ADDENDUM #1

Date of Addendum: JAN 7, 2021

UWMC 7NE Nursing Unit Upgrade UW Project No. 207310

Prepared by Buffalo Design Architecture | Interiors

title: floor and finish
 plan - north

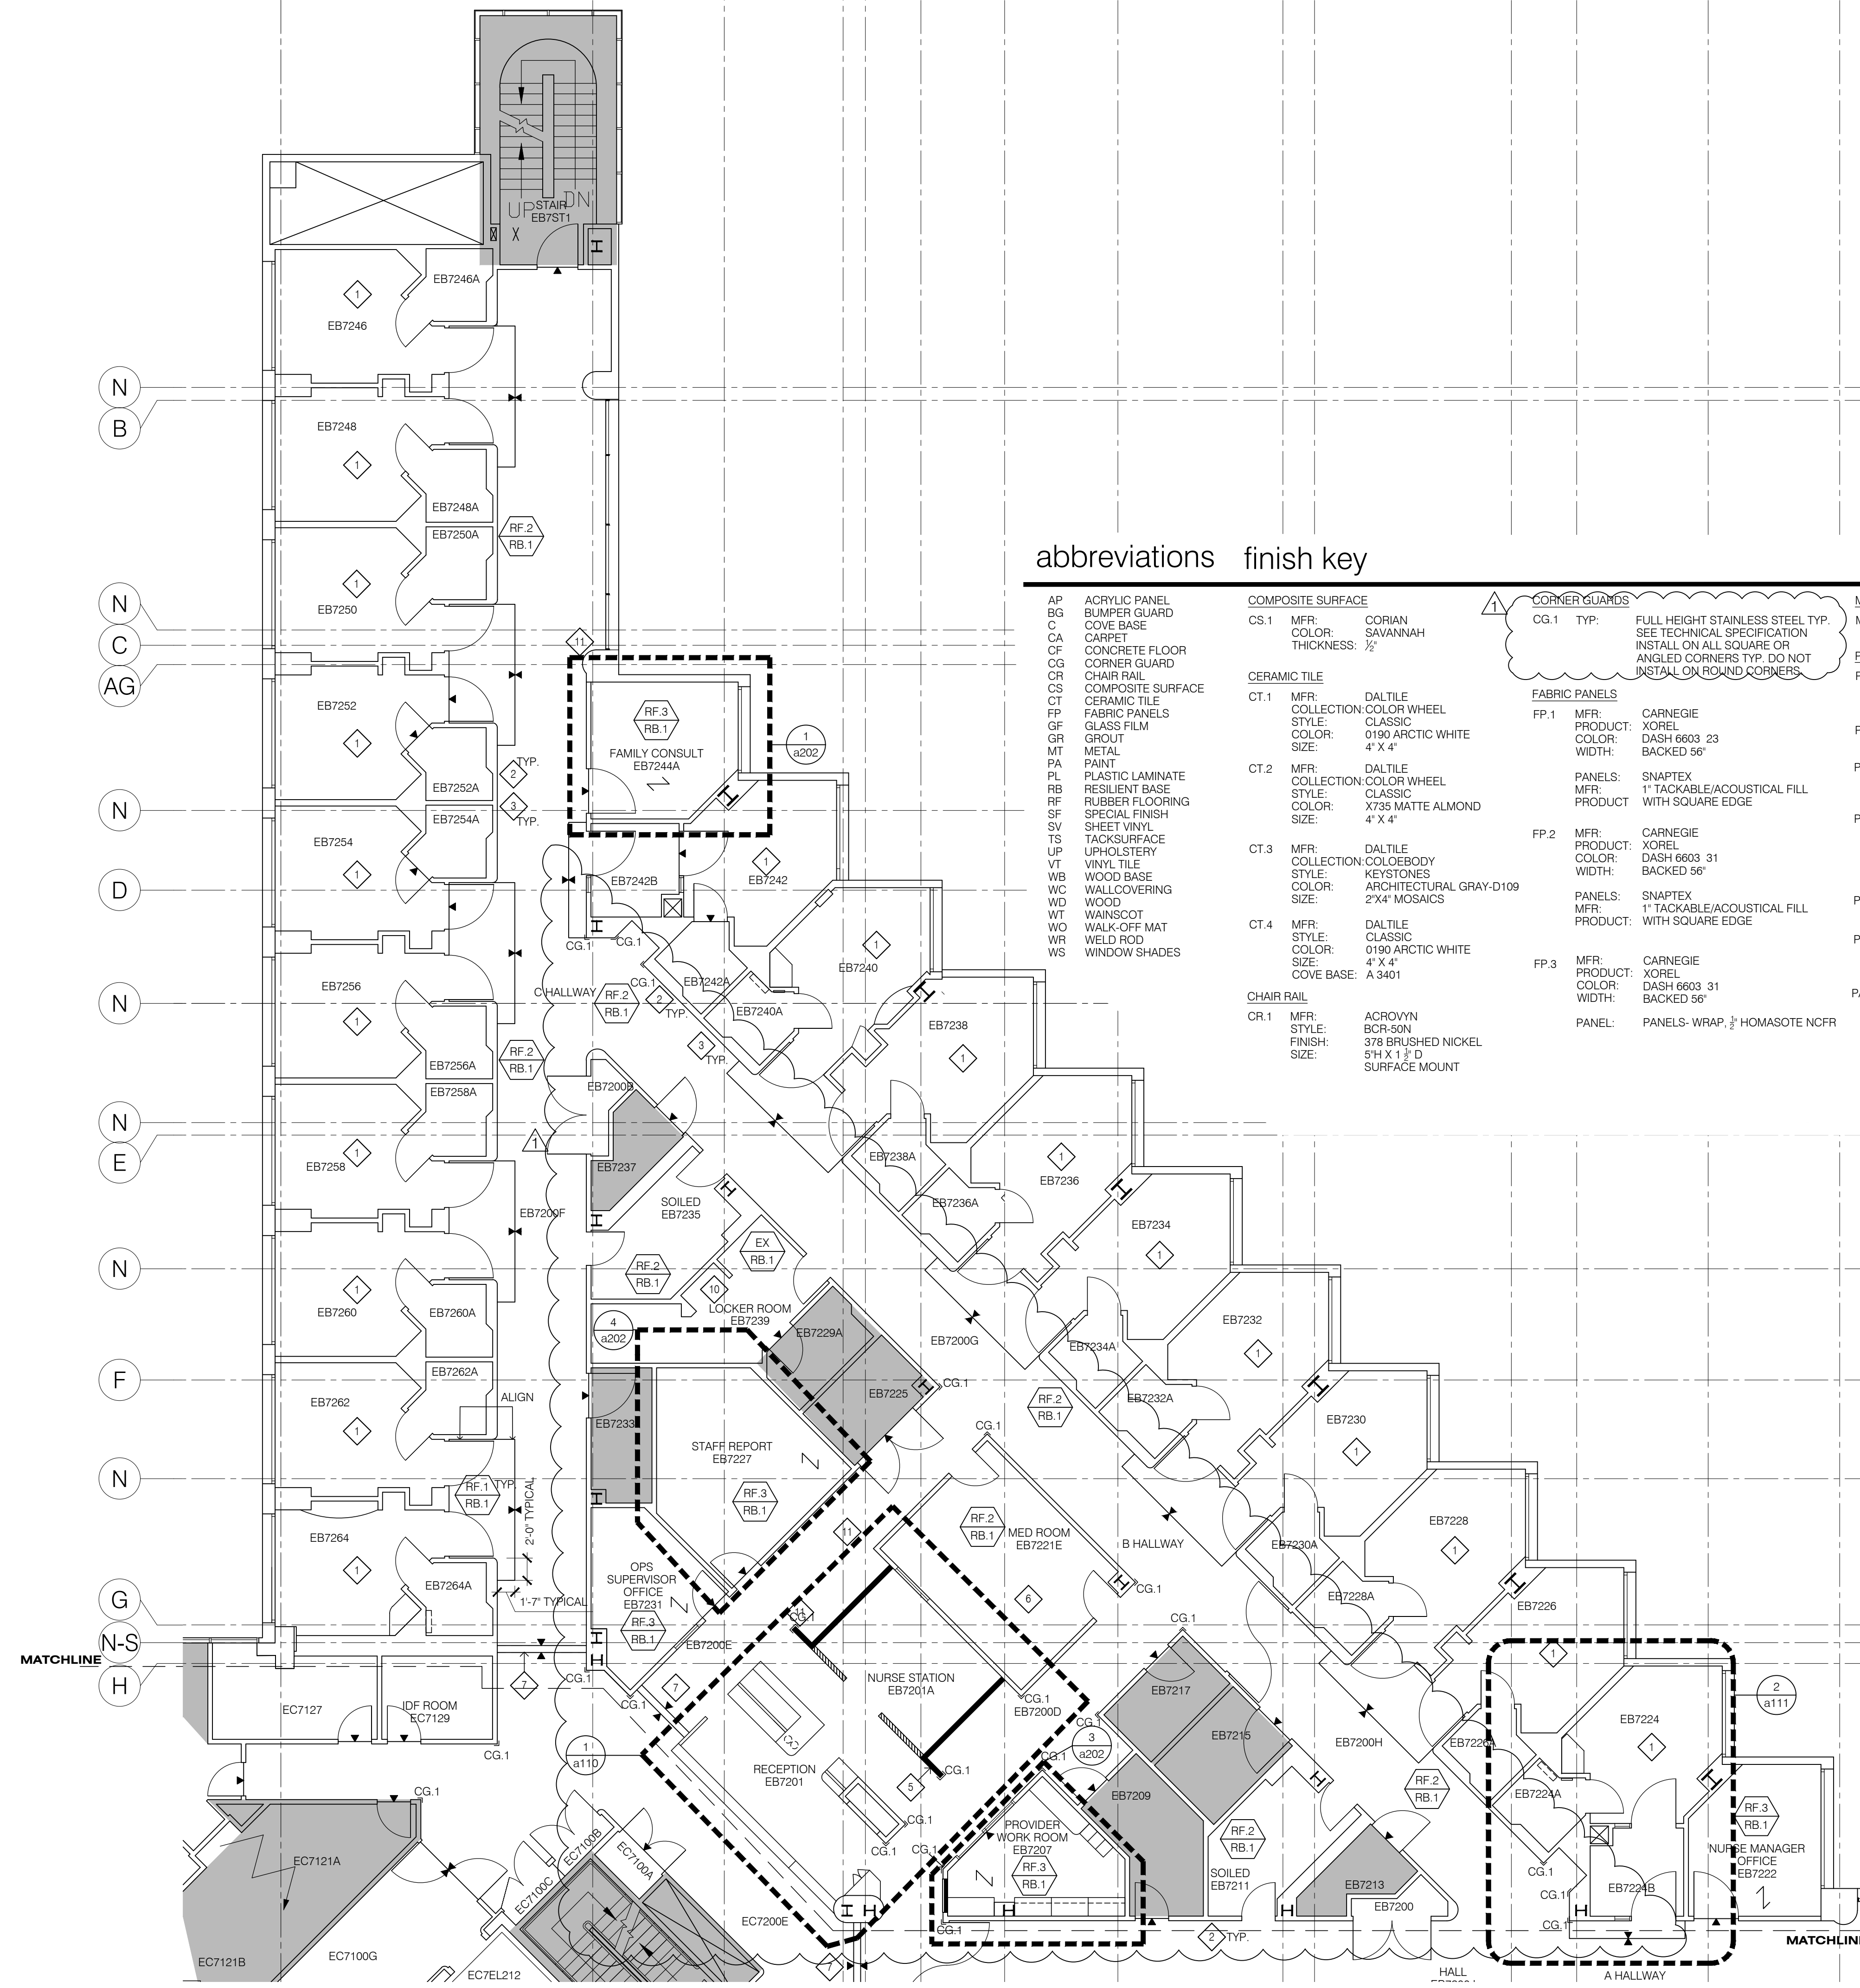
| Item | Drawing No. | Description of Change |
|------|-------------|--|
| 4.2 | a105 | Corner guards shown on attached plan. Add flooring type RF-6 and RF-7. Revise keynote 3 to remove decorative reveal before patching. |

title: floor plan -
south

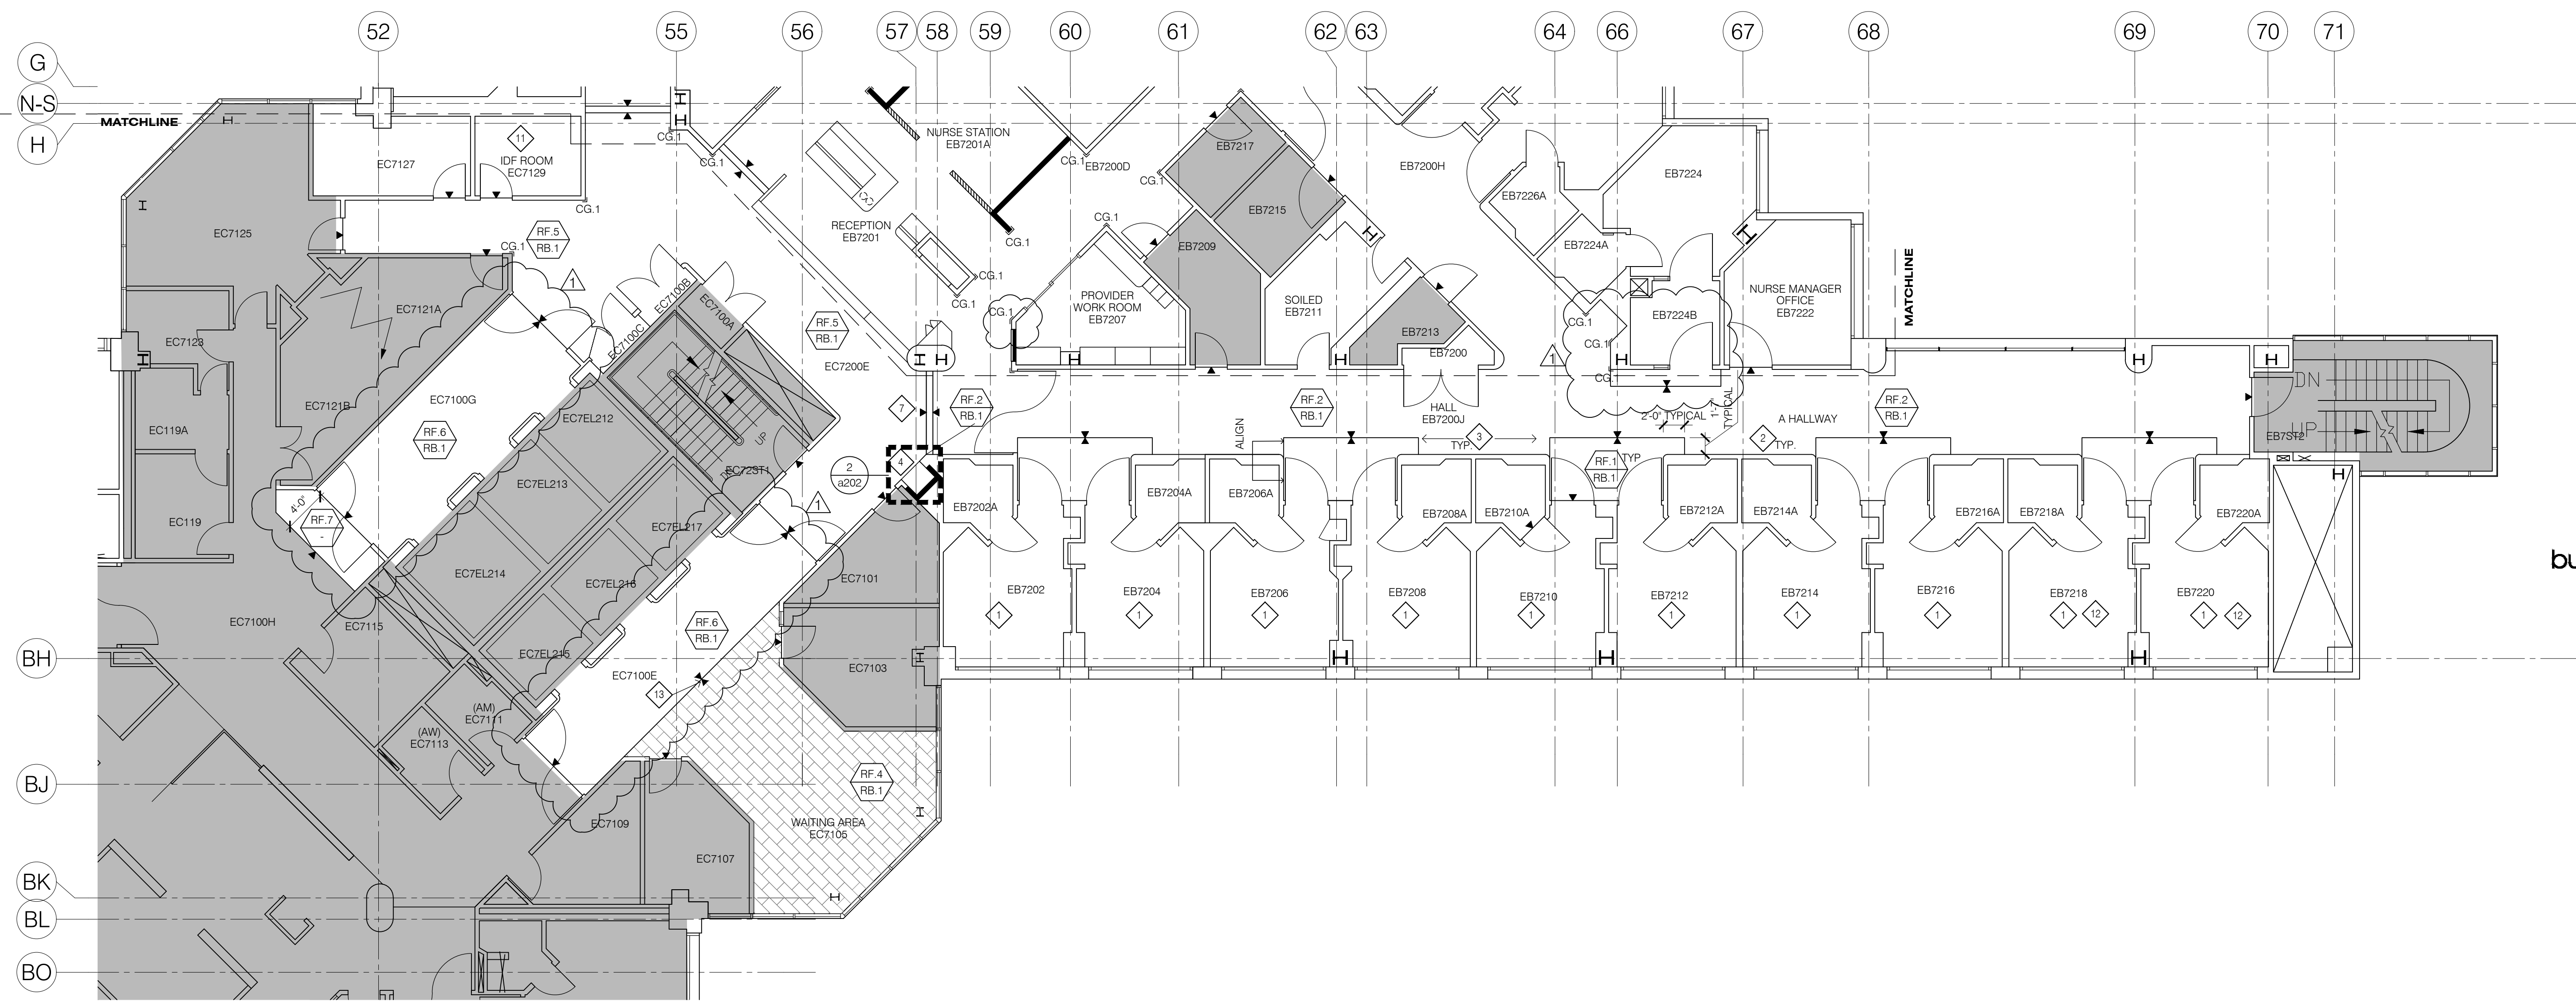
| Item | Drawing No. | Description of Change |
|------|-------------|--|
| 4.3 | a106 | Corner guards shown on attached plan. Add flooring type RF-6 and RF-7. Revise keynote 3 to remove decorative reveal before patching. Extend new flooring installation on south end of Service Elevator lobby. |
